**Re: Sampling Plan for Evacuation Pit and Pile at POL Wash
Rack Site**

Soil Sampling Plan

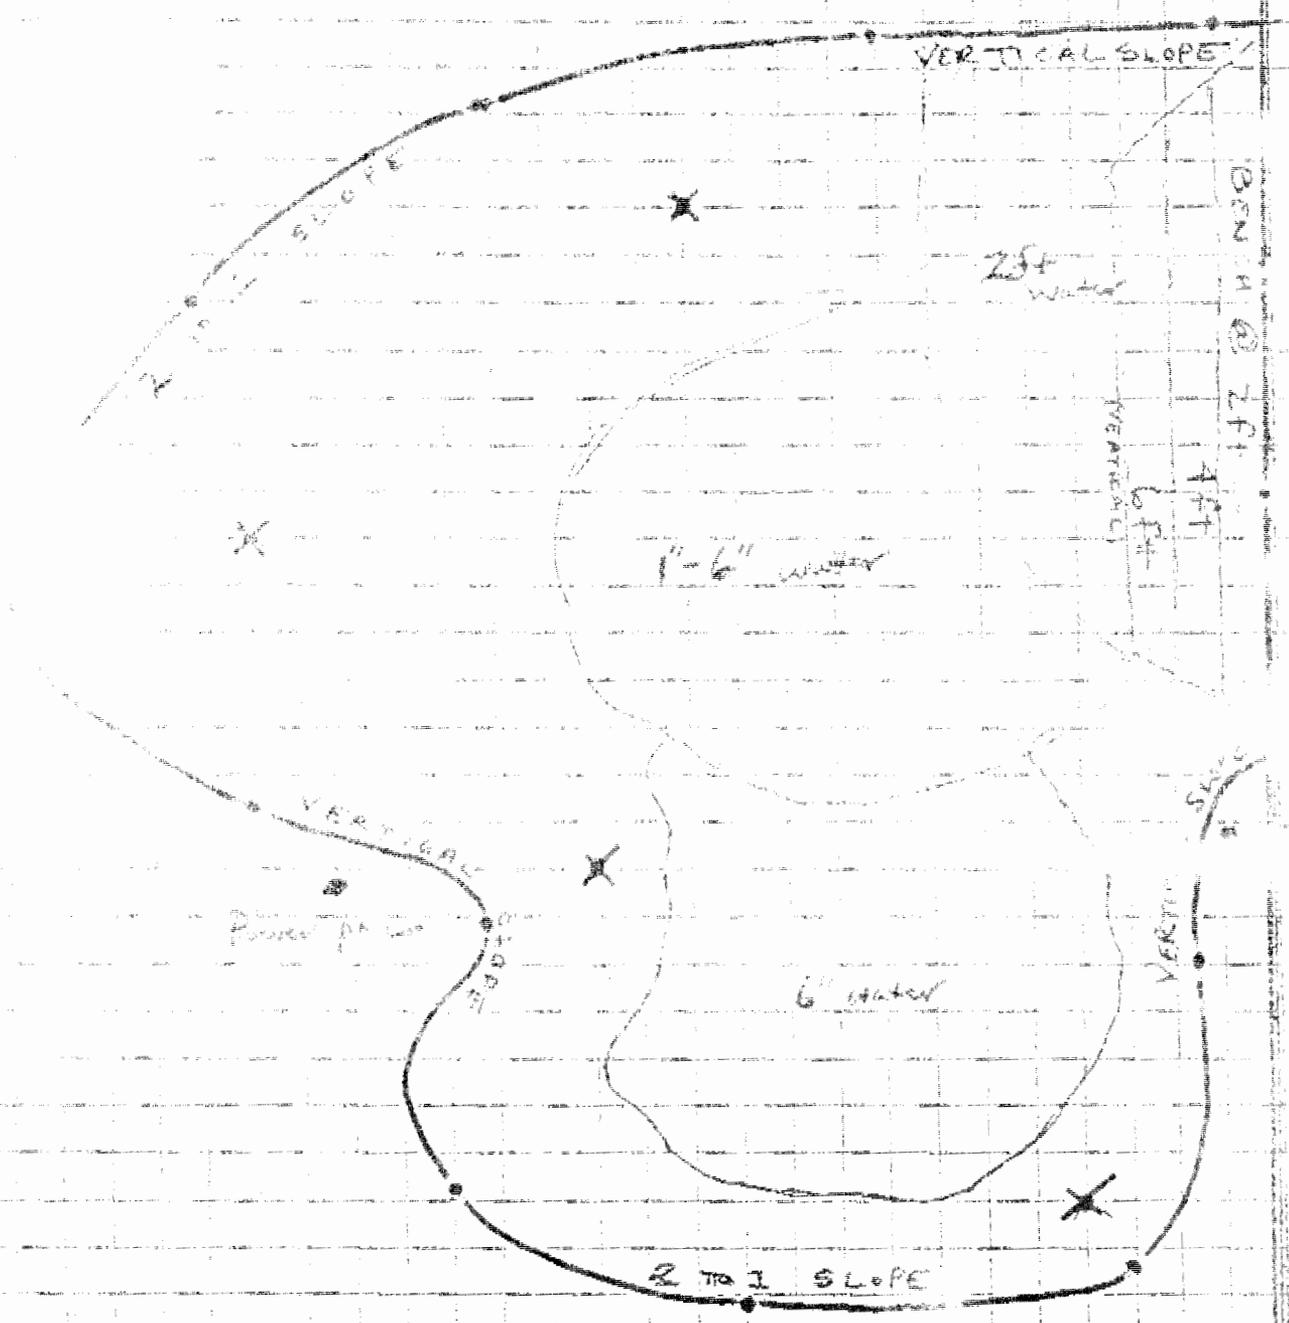
At this point, it is our recommendation that the excavation be sampled for verification of cleanliness (total benzene via method 8240) and backfilled. The existing washrack fence will define the limits of excavation should future remediation in this area be necessary. The attached map depicts the excavated area at present, together with proposed verification sampling points. These sampling points were chosen based on field observations and should be visually refined on-site to reflect worst case samples.

This letter is written as to inform you that approval cannot be granted for the sampling plan submitted to the New Mexico Environment Department (NMED) on January 7, 1992 (revised February 20, 1992) until provisions for Quality Assurance/ Quality Control are added. Enclosed are the Components of an Adequate QA/QC Plan.
